June 14, 2021
Merrick Project No. 6512069201

Re: Lincoln Station Apartments – Site Improvement Plan Application and Plat Application

Merrick & Company has reviewed the comments dated June 2, 2021 regarding the Lincoln Station Apartments Site Improvement Plan Application. The following summarizes Merrick's responses to the comments provided by the City of Lone Tree Community Development Department.

SITE PLAN - FIRE ACCESS SCALE: 1" = 30'-0" **1**

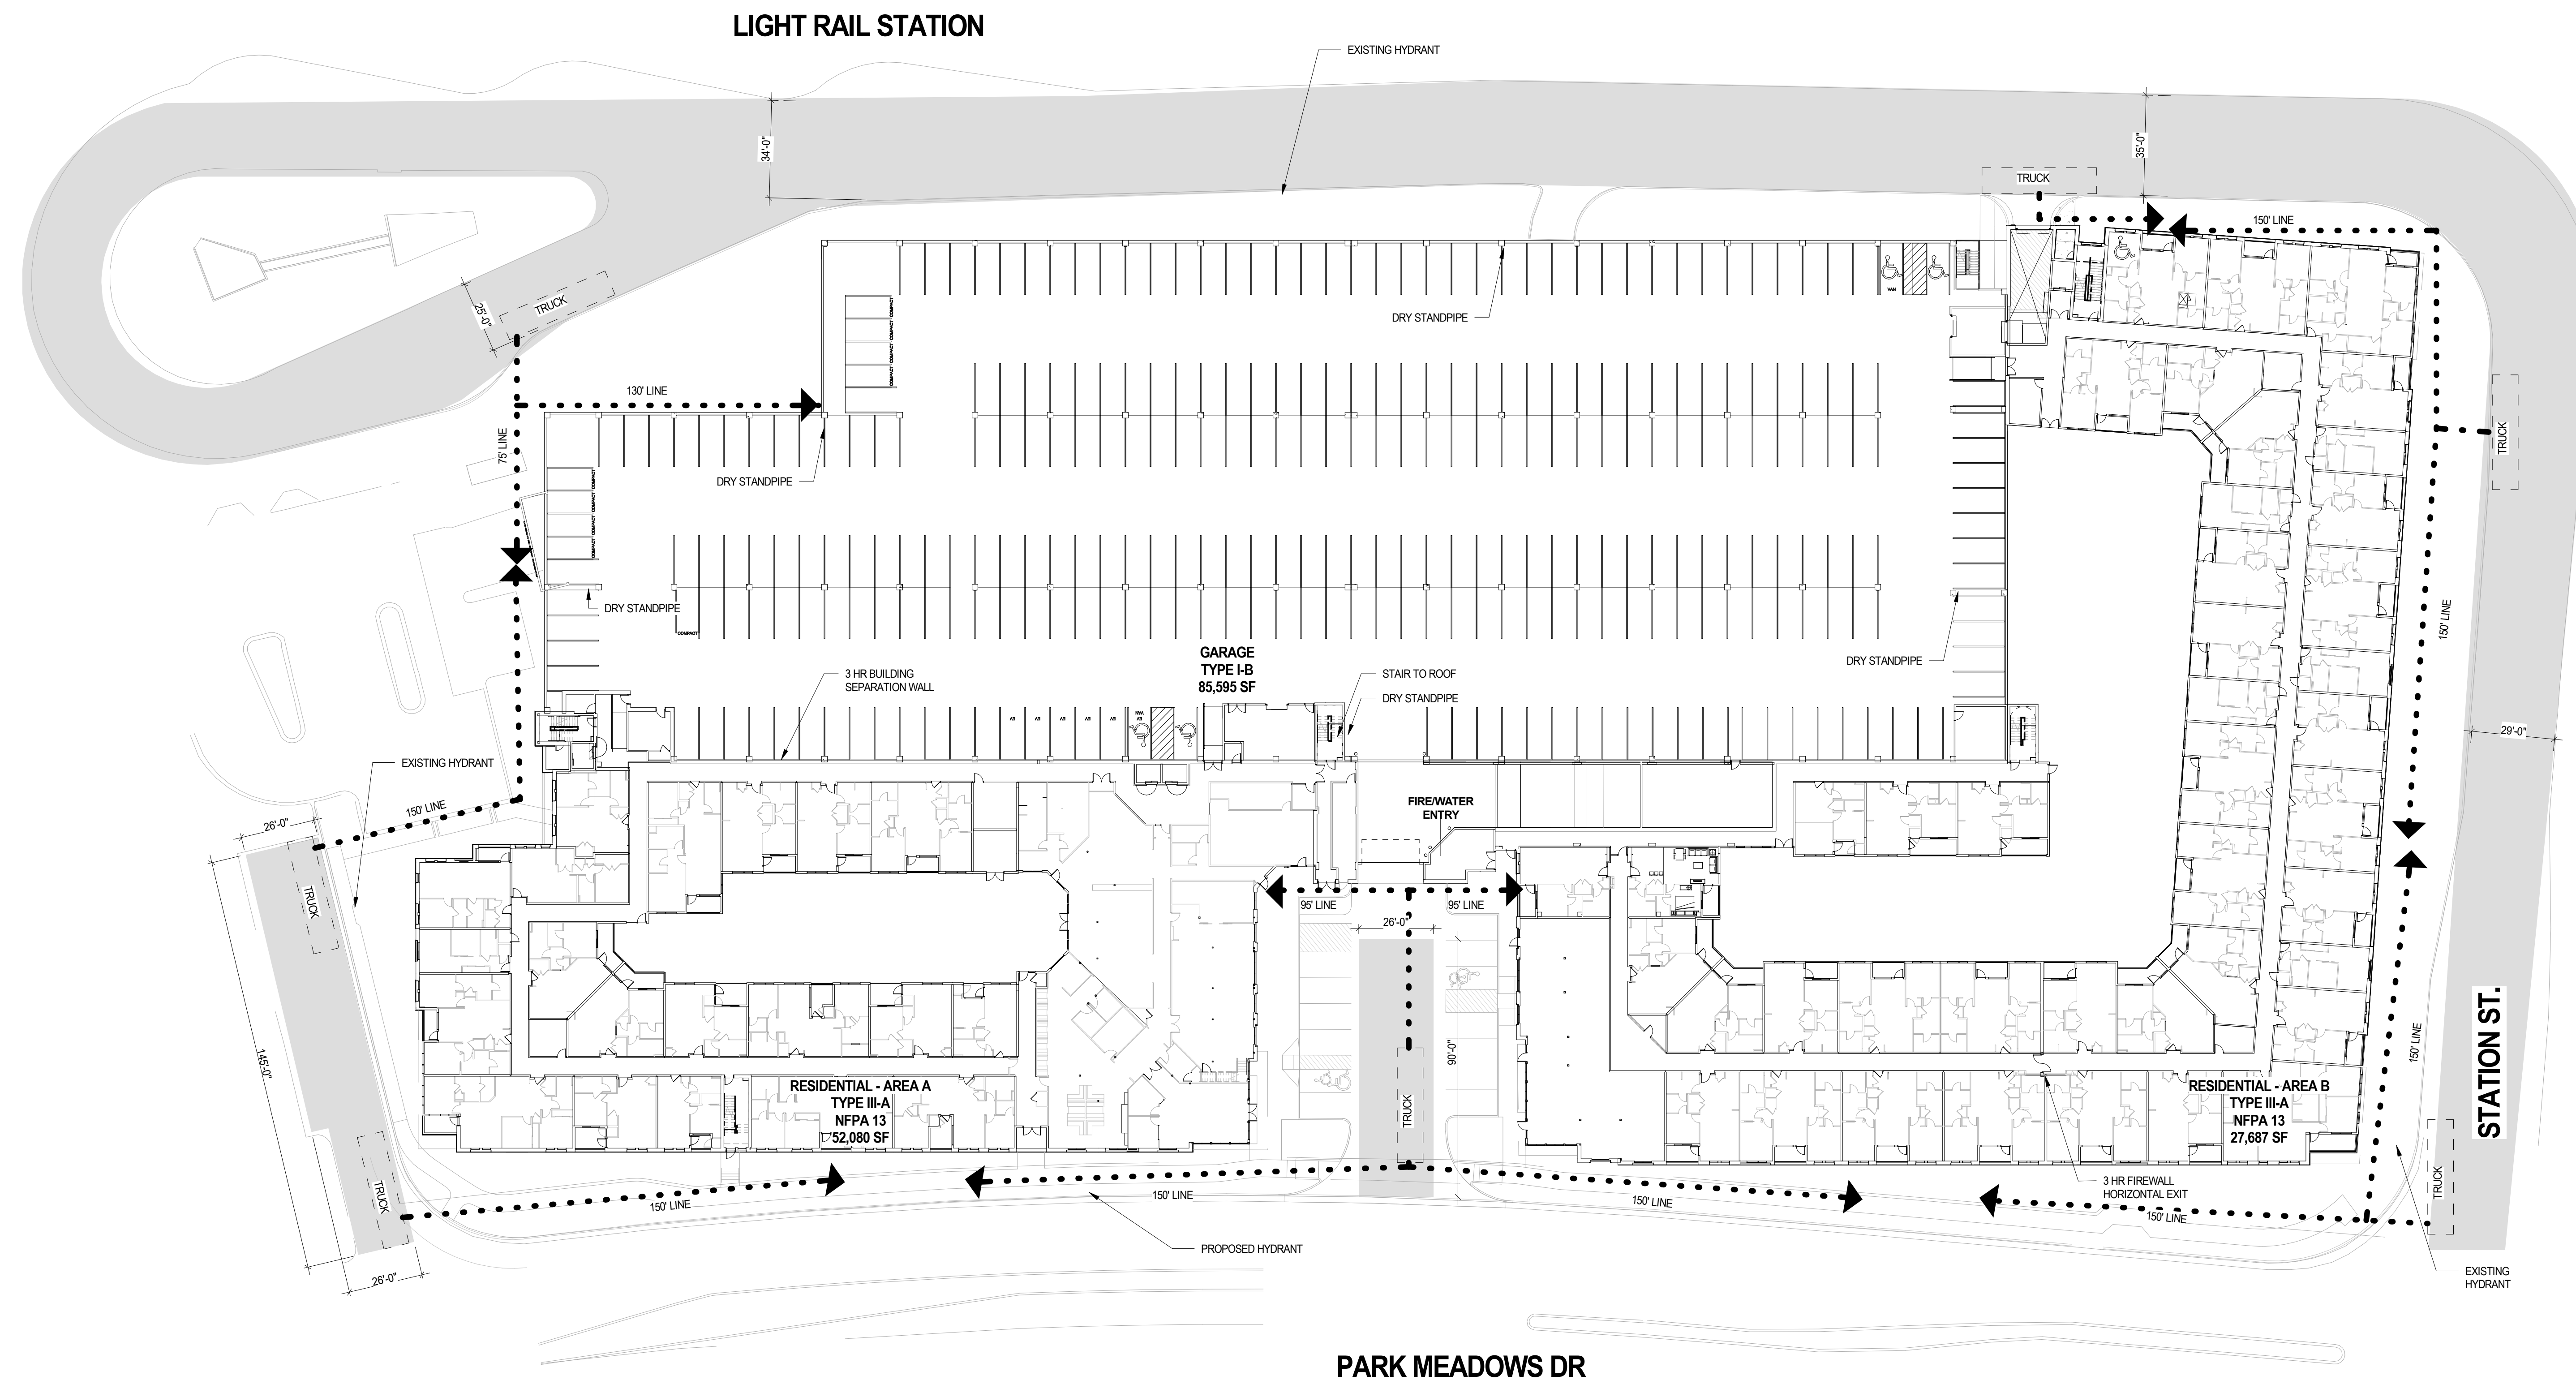
Response: Understood.
 6. Provide roads widths on Station Street in order to meet aerial apparatus requirement.
Response: See provided Fire Access Plan showing Station Street Road Widths.
